LANDSCAPE PLAN

BRAKES PLUS

SITE DEVELOPMENT PLAN

Landscape Plans_V1.pdf Markup Summary

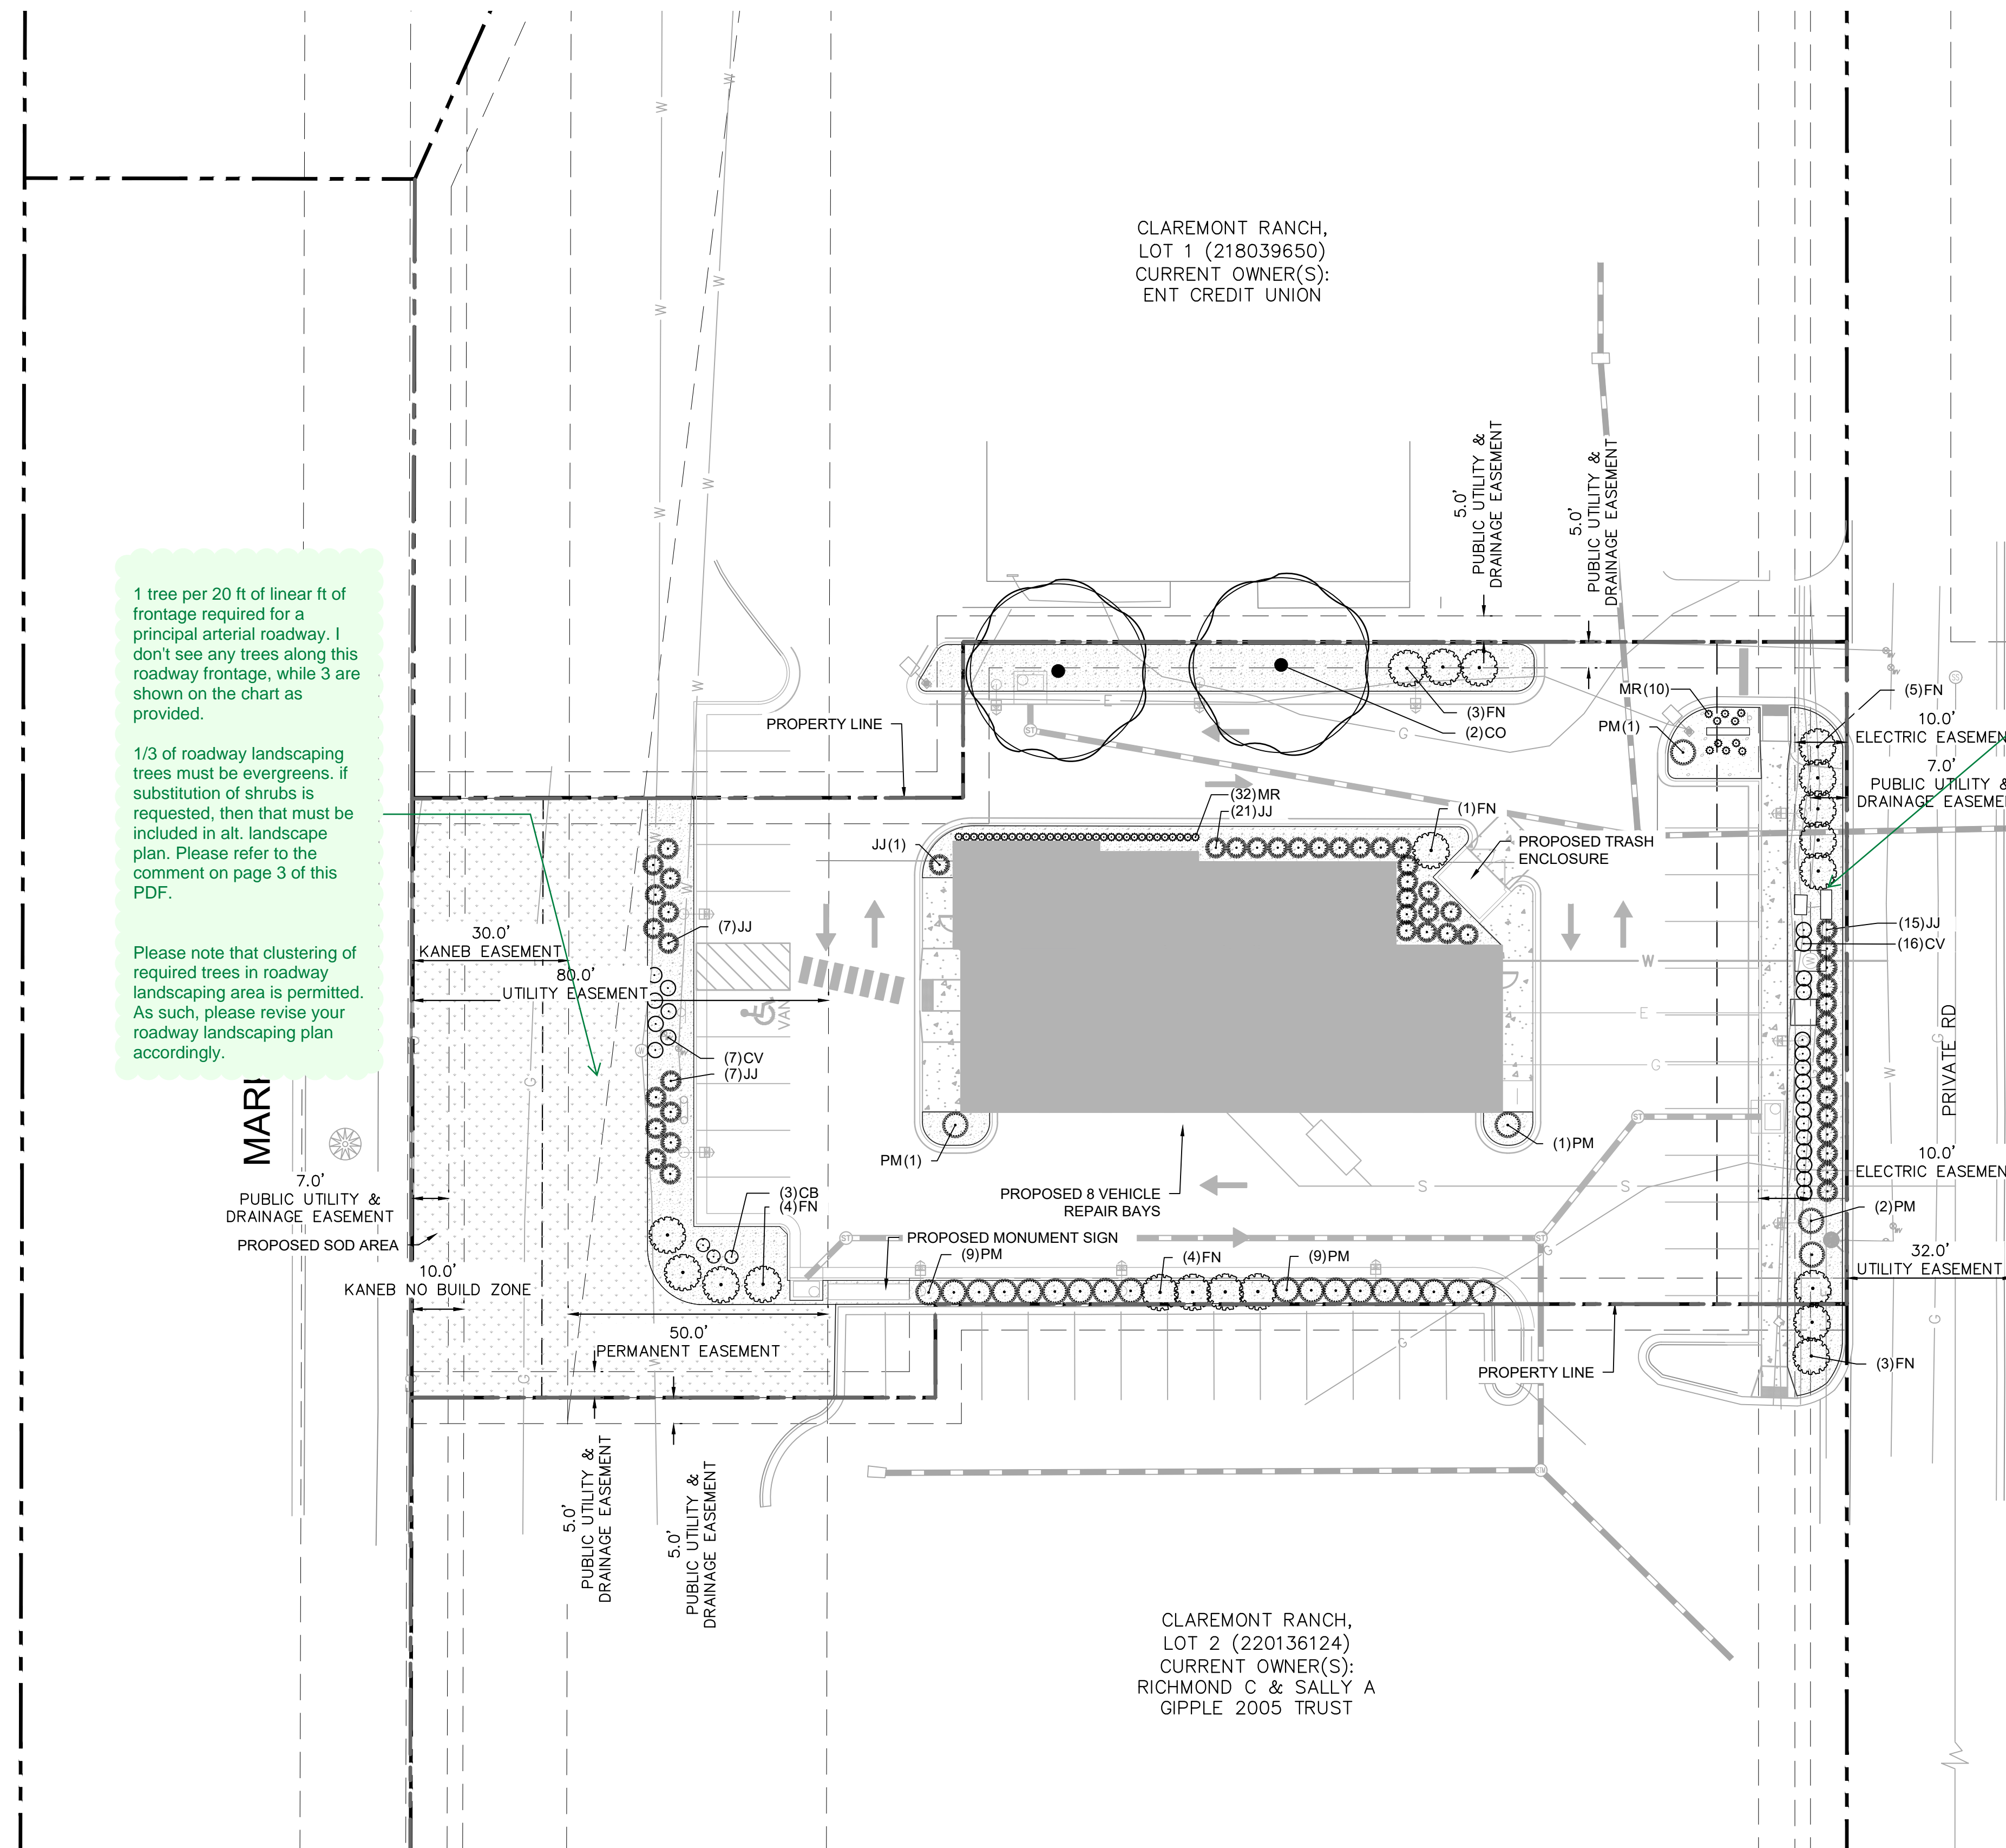
BRACKETED PLUS
If proposed landscaping will not meet any portion of the landscaping standards, then an alternative landscape plan must be requested. If an alternative landscape plan is requested, then please include justification of that in the letter of intent by explaining how the proposed landscaping meets the purpose of the code and promotes the concepts contained in the Landscape and Water Conservation Manual.

1 tree per 20 ft of linear ft of frontage required for a principal arterial roadway. I don't see any trees along this roadway frontage, while 3 are shown on the chart as provided.

1/3 of roadway landscaping trees must be evergreens, if substitution of shrubs is requested, then that must be included in alt. landscape plan. Please refer to the comment on page 3 of this PDF.

Please note that clustering of required trees in roadway landscaping area is permitted. As such, please revise your roadway landscaping plan accordingly.

Please revise and identify 10-ft roadway landscaping depth as required per LDC Ch. 6 Roadway Landscaping standards.

This roadway landscaping requirement applies for any roadway.

1 tree per 30 ft of linear ft of frontage required for a non-arterial roadway. 1/3 of roadway landscaping trees must be evergreens.

EL PASO COUNTY CODE TABLE

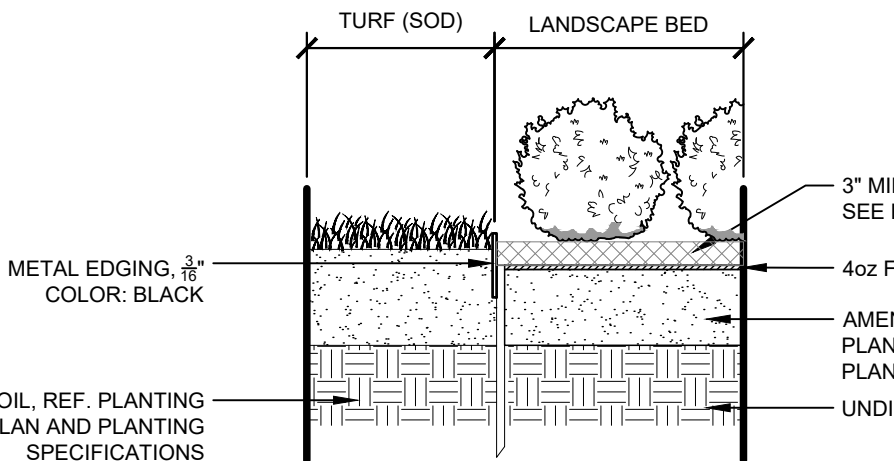
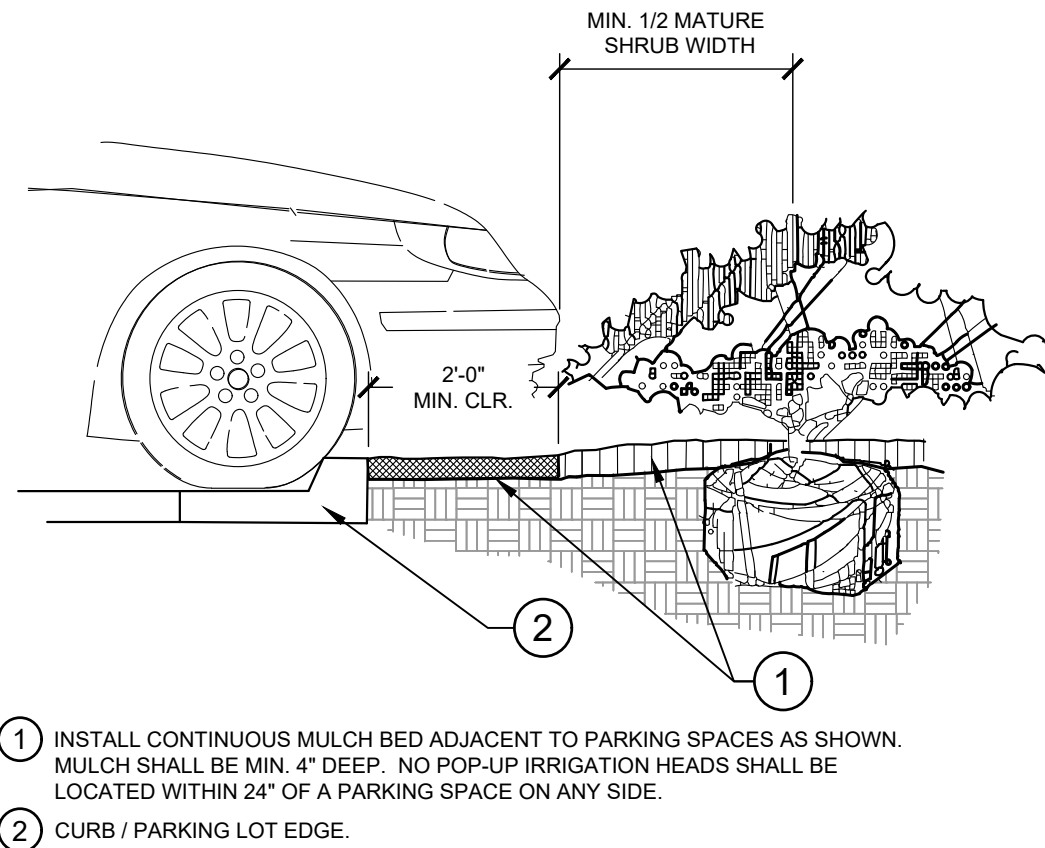
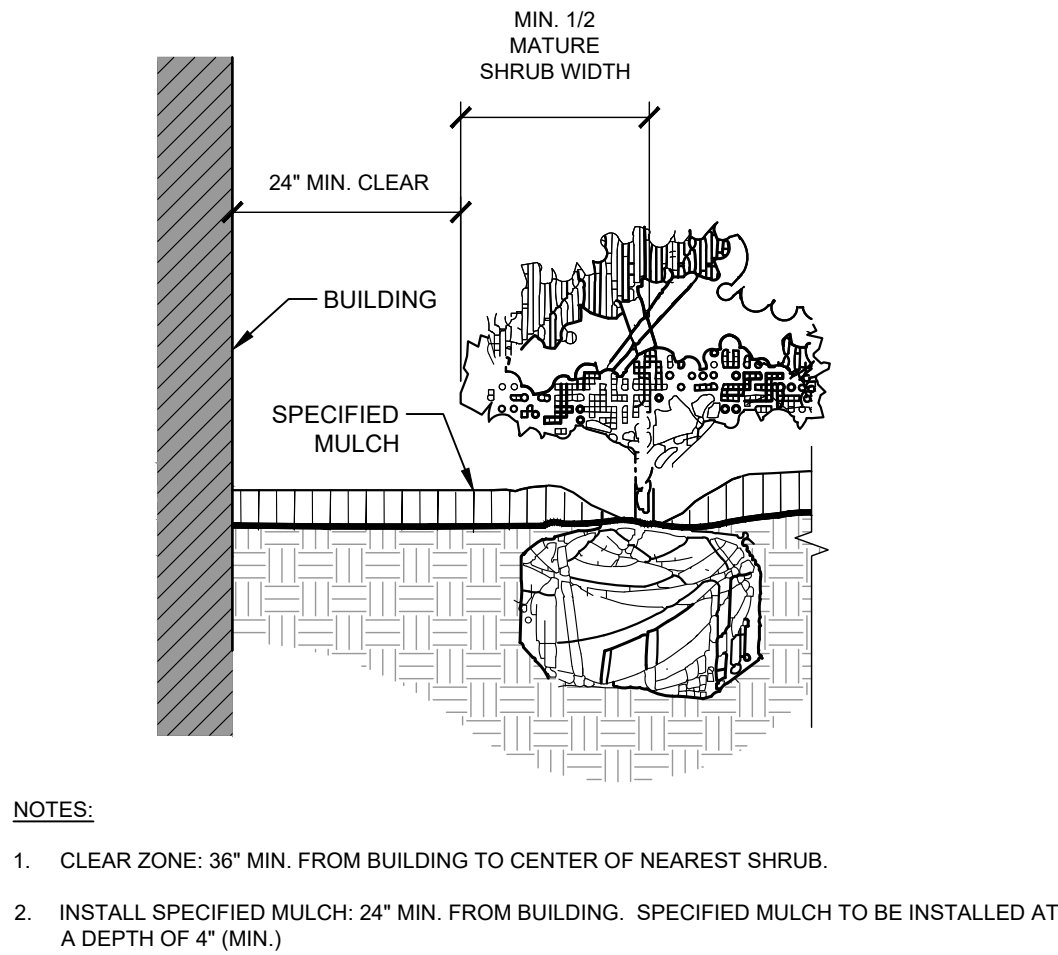
Please revise or demonstrate compliance with the ground cover requirement below. If requirement will not be met, then please include this in an alternative landscape plan request.

(2) Required Live Material Ground Cover.
Unless otherwise allowed, required landscape areas shall include a minimum of 75% ground cover by living grass or other living plant materials at maturity. The remaining 25% of the required landscape area may be covered with bark, wood chips, rock, stone, or other landscape materials or may be designed as hard-surfaced pedestrian areas. The foliage crown of trees shall not be counted in meeting the ground cover requirement.

The Roadway Landscaping standards (not setbacks as indicated in your chart subtitle) do not provide an allowance for substituting required trees with shrubs. If this substitution is requested, it will need to be included and justified as part of an alternative landscape plan. This same comment applies to the Motor Vehicle Landscaping, where shrubs are proposed to substitute a requirement.

Also, I don't see 3 trees provided as part of the roadway landscaping for Marksheffel Rd. Please revise the table or provide the 3 trees as shown on the table.

Please note that appropriate justification will be required if you're seeking to reduce the number of provided trees.

Only 50% of the required internal landscape trees (2 in this case) may be replaced with shrubs adjacent to retail store fronts where the view of wall signs may be obstructed.

If this requirement won't be met, then please include and justify it in the letter of intent.

Please note that clustering of required trees in roadway landscaping area is permitted. As such, please revise your roadway landscaping plan accordingly.
